# Access Compliance Report

## Public Rights-of-Way

### (Curb Ramps)

Intersection ID: 10014442	Main Street: UNIVERSITY_CITY_BV	Cross Street: N/A	Location: NE
ADA ID: 7891143F2878	Ramp Type: Directional1	Initial Pass/Fail: Fail	Overall Compliance: No
			Severity Score: 13.75

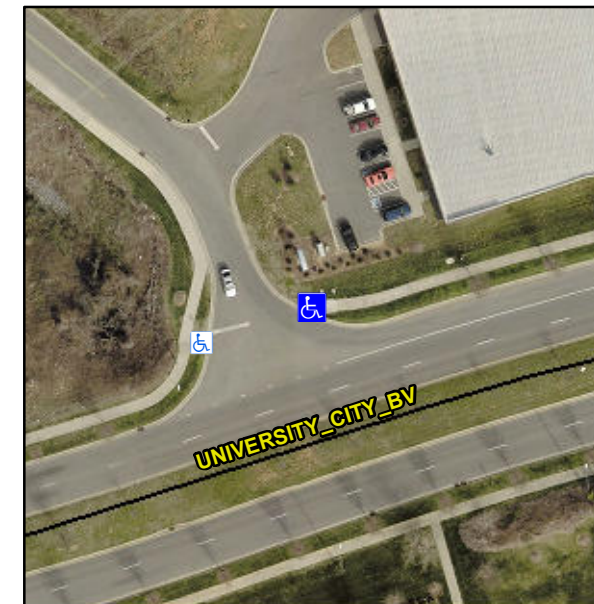
**R304.2.2, R304.5.3**

Compliance	Description	Data	Compliance	Description	Data
N/A	Ramp Length (in)	141.0	N/A	Grade Break?	N/A
Yes	Ramp Width (in)	69.0	N/A	Grade Break Slope (%)	0.0
No	Ramp Slope (%)	8.4	N/A	Grade Break XSlope (%)	0.0
No	Ramp XSlope (%)	4.7			
N/A	Flare Type LT	N/A	N/A	Flare Type RT	N/A
N/A	Flare Slope LT (%)	N/A	N/A	Flare Slope RT (%)	0.0
N/A	Flare Traversable LT?	N/A	N/A	Flare Traversable RT?	N/A
N/A	Landing Length (in)	0.0	N/A	DWS Provided?	N/A
N/A	Landing Width (in)	0.0	N/A	DWS Contrast?	N/A
N/A	Landing Slope (%)	0.0	N/A	DWS Length (in)	N/A
N/A	Landing X Slope (%)	0.0	N/A	DWS Full Width?	N/A
N/A	Landing Curb? (Y/N)	N/A	N/A	DWS Offset LT (in)	N/A
N/A	Shared Landing?	N/A	N/A	DWS Offset RT (in)	N/A
N/A	Gutter Ponding?	0.0	N/A	Gutter Slope (%)	N/A
N/A	Gutter Lip Ht (in)	0.0	N/A	Gutter X Slope (%)	N/A
N/A	Painted X Walk1?	No		Road Slope (%)	3.2
	X Walk 1 Direction	To W		Road X Slope (%)	1.0
	X Walk 1 Width (in)	N/A		Clear Space?	N/A

**Remove & Replace Entire Ramp.**
